CAA DECISION LETTER

INTRODUCTION OF INSTRUMENT APPROACH PROCEDURES (IAPs) TO RUNWAY 03 AT CRANFIELD AIRPORT

CRANFIELD
RNAV (GNSS)
RWY 03
 (ACFT CAT A,B,C)

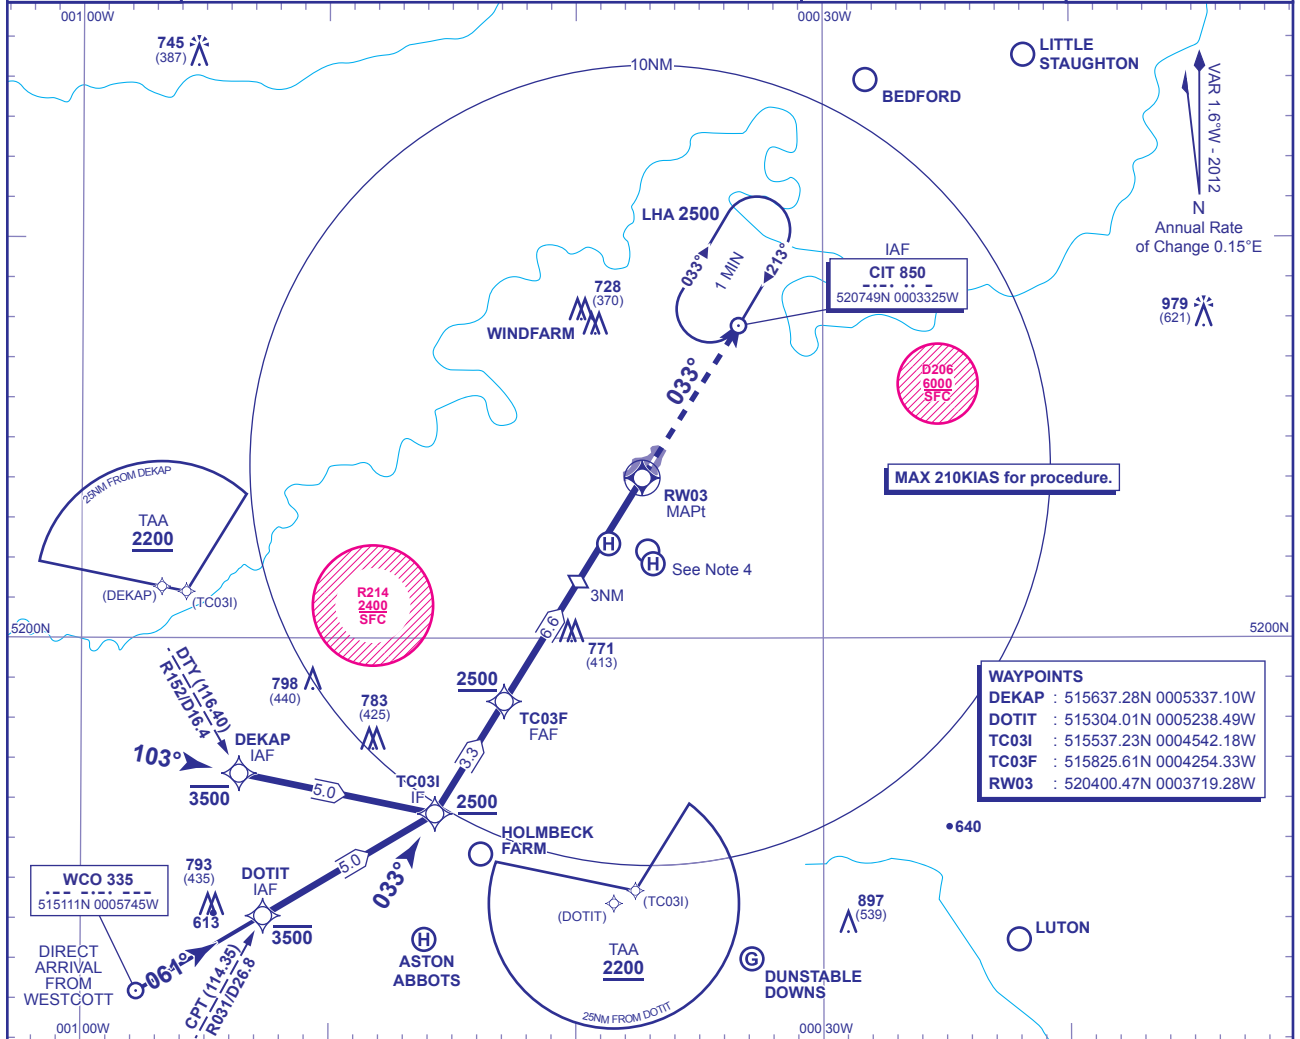
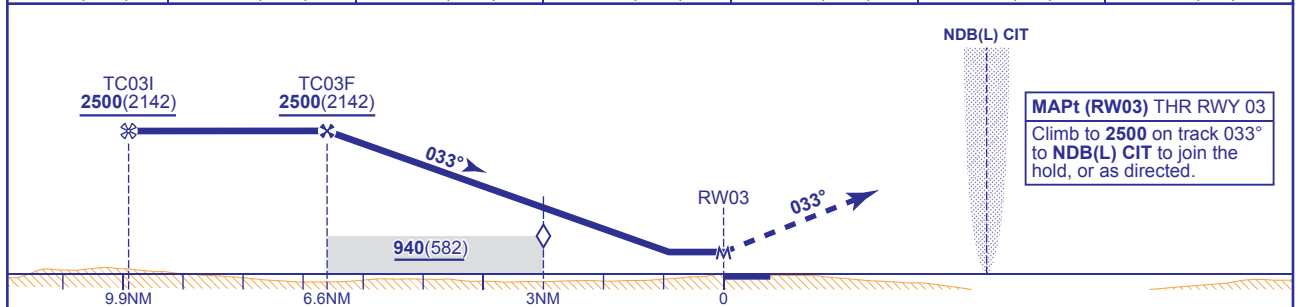
Runway 03 centreline, and a RNAV (GNSS) Non-Precision Approach procedure also to the north of the Runway 03 centreline. Both IAPs are depicted in the draft charts at Enclosure 1.

- 3.2.1 My primary duty is to maintain a high standard of safety in the provision of air traffic services and this takes primacy over all other duties.¹ The proposed new procedures would provide a full instrument approach capability to Runway 03 and, particularly in the case of the RNAV (GNSS) procedure, offer substantial improvements to the landing minima in comparison to the visual circling manoeuvre minima following an instrument approach to Runway 21 (about 460 ft lower for larger aircraft).

- 6.2 The intention is that the NDB/DME procedure will become effective on the AIRAC 7/2012 implementation date of 28 June 2012, and as the RNAV (GNSS) procedures requires a double AIRAC schedule; it would become effective at AIRAC 8/2012 on 26 July 2012. My staff will review the effectiveness of the arrangements 12 months after introduction and the results of this review will be published.

**CRANFIELD
NDB(L) DME
RWY 03**
(ACFT CAT A,B,C)

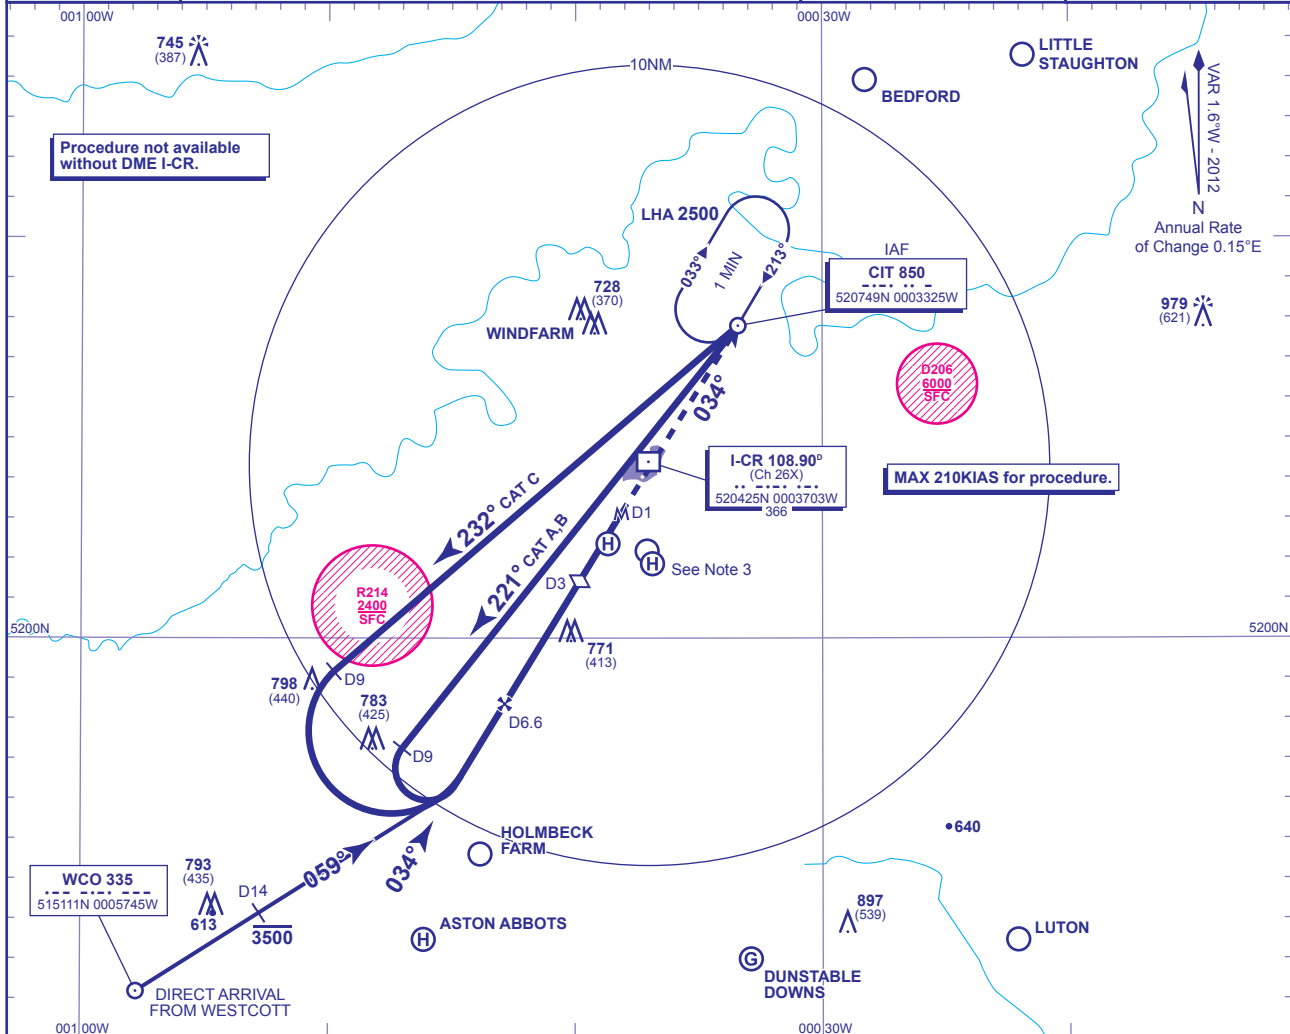
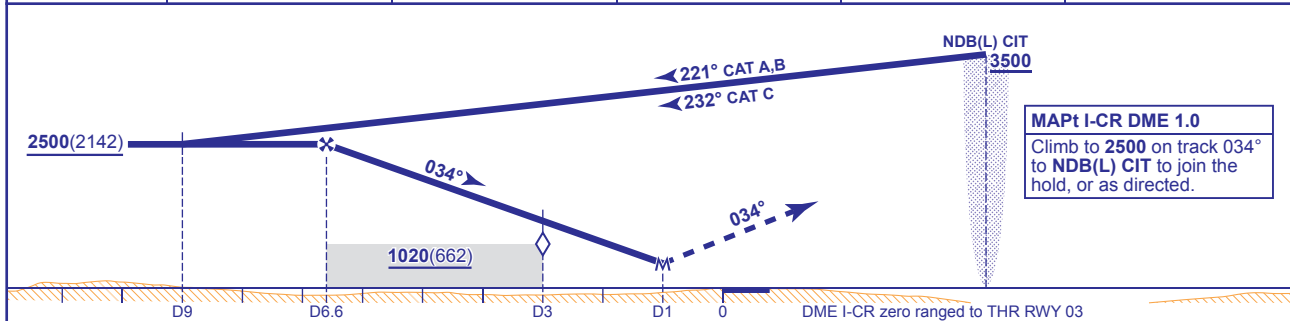
- 2.5 Cranfield Airport does not currently have a surveillance radar facility, so it is necessary, for arriving aircraft operating under Instrument Flight Rules to carry out the whole of the published IAP. The proposed NDB procedure for Runway 03 includes a Direct Approach option thus negating the requirement for pilots to fly the whole procedure.
- 2.6 In order to support the introduction of the proposed IAPs, Cranfield Airport have plans in place for the installation of approach lighting, Precision Approach Path Indicators, stop lighting and the associated control and monitoring system for Runway 03. Work is due to commence during April 12, to be completed by the planned implementation date.
